RECEIPT DATE: 12/6/17 **ONSITE SEWAGE DISPOSAL SYSTEM** P 562351

7156 MINK HOLLOW ROAD
 HIGHLAND, MD 20777

SEPTIC PERMIT PLAN

Re: Septic Site Plan
Percolation Certification Plan
7156 Mink Hollow Road
Revised Plan Submissions

**2,000 GALLON SEPTIC TANK
2-Compartment**

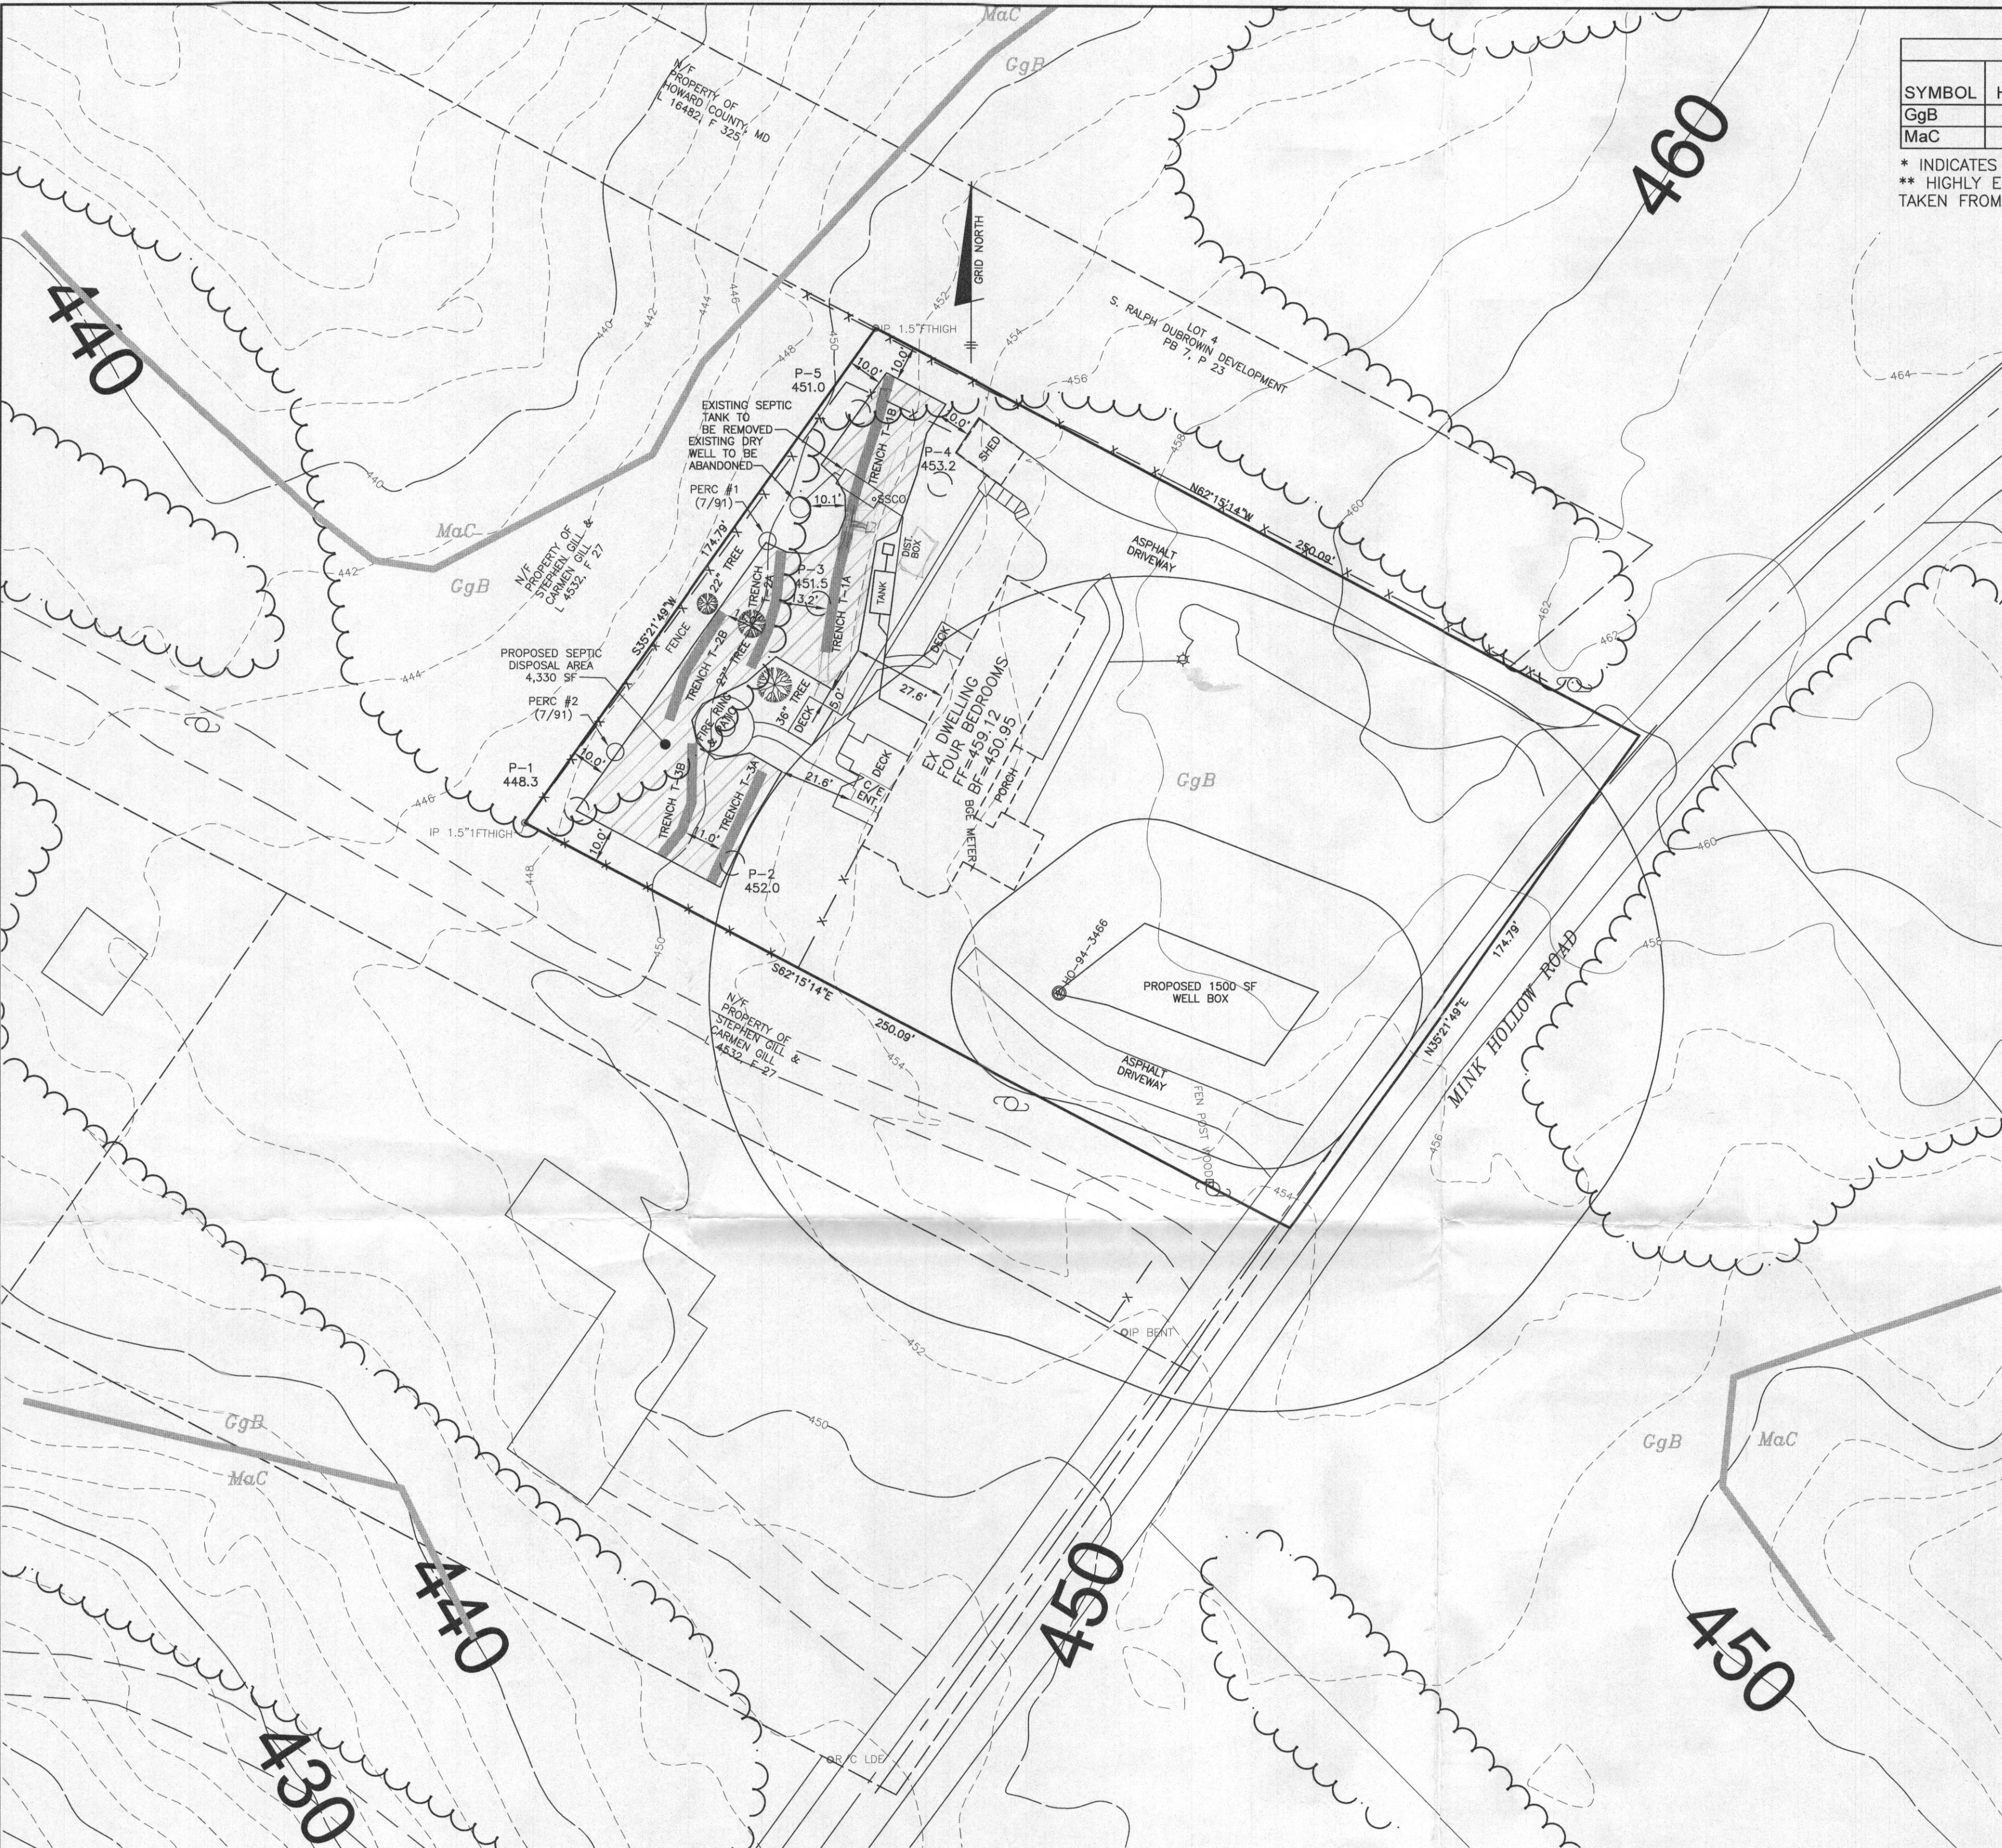
I just took one last look at the OSDS Plan and I noticed it's missing the cross section/details about the septic tank.

Hank, It would just be a 2000 gallon 2 compartment tank. Could you attach this to the permit? Thanks, John

SEWER PROFILE
 SCALE: VERTICAL 1"=3', HORIZONTAL 1"=30'

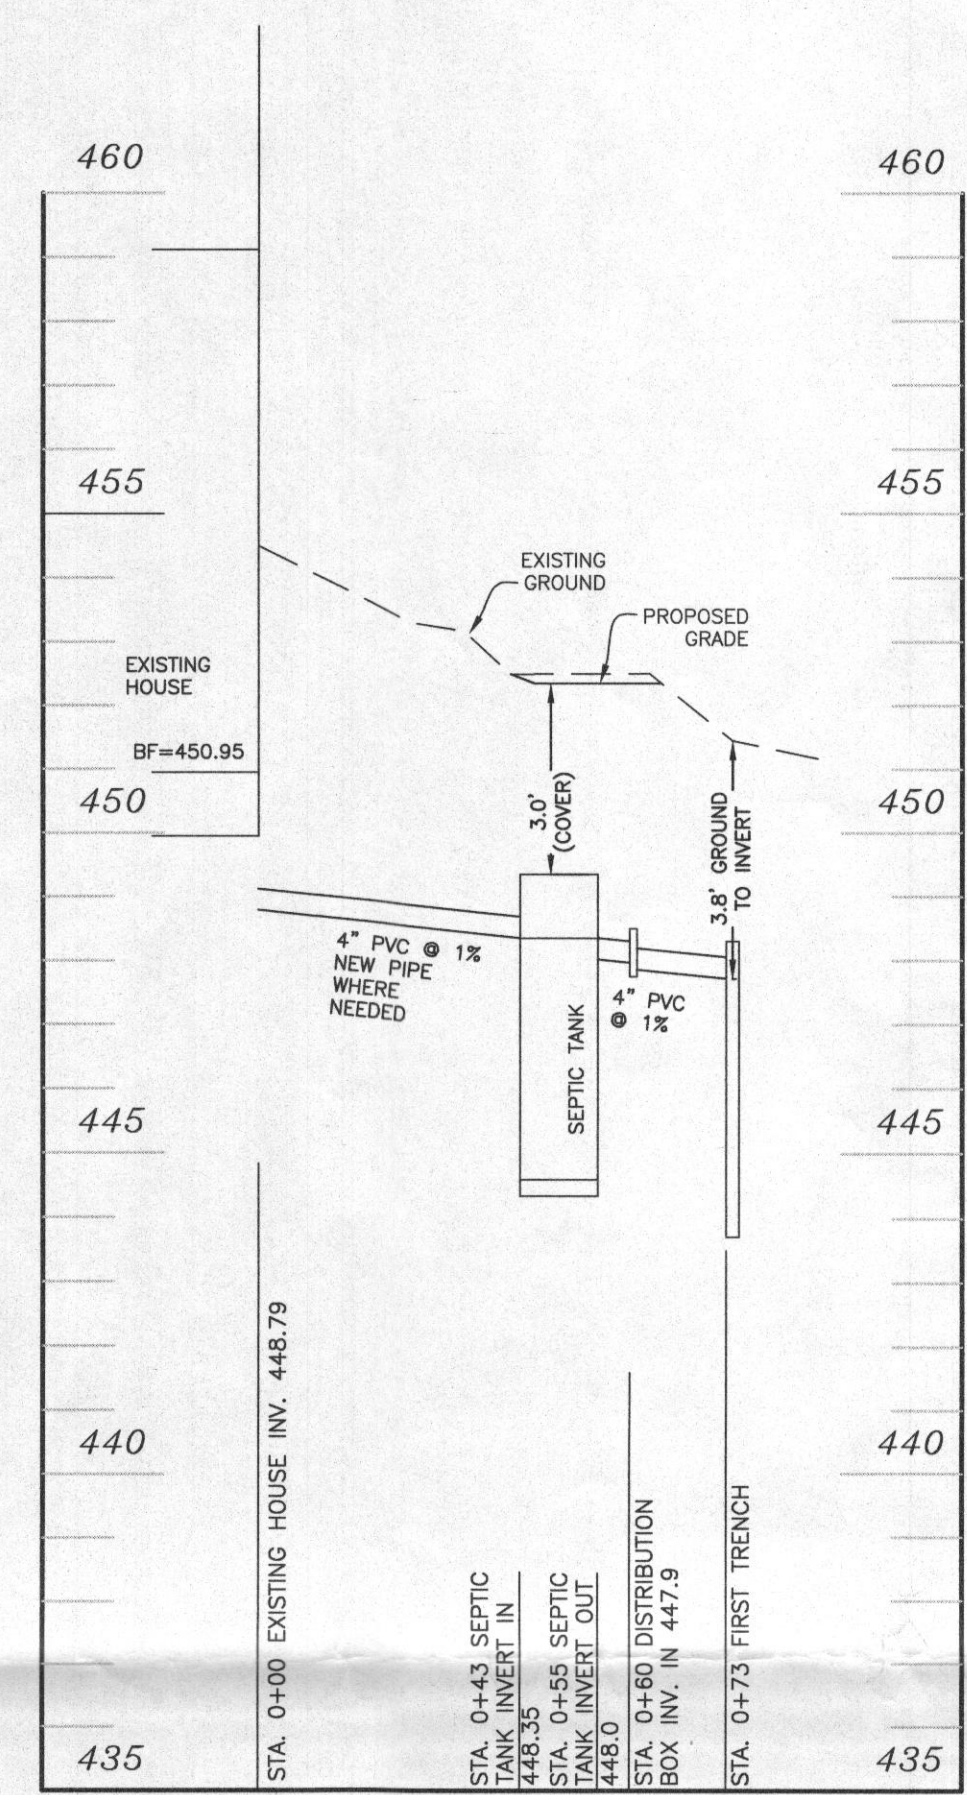
Per Jeff, the depth of the sewer line will need to be determined now and noted on the OSDS Plan so we know it will make fall. The initial trench invert must not exceed 4 feet or add pump tank. The existing septic tank will need to be completely removed in order to run the initial trench through that area. Remove portion of SDA where the new tank is located because the area won't be used (see attachment).

Hank, thanks. I am revising the plan now. If I specify a 1.0% outfall I can get the invert of the lateral to be 4.0 feet below grade. See attached. If the invert out of the house is less than 2.5' below the slab I would recommend steepening the pipe and not raising the tank. Let me know what you think. John
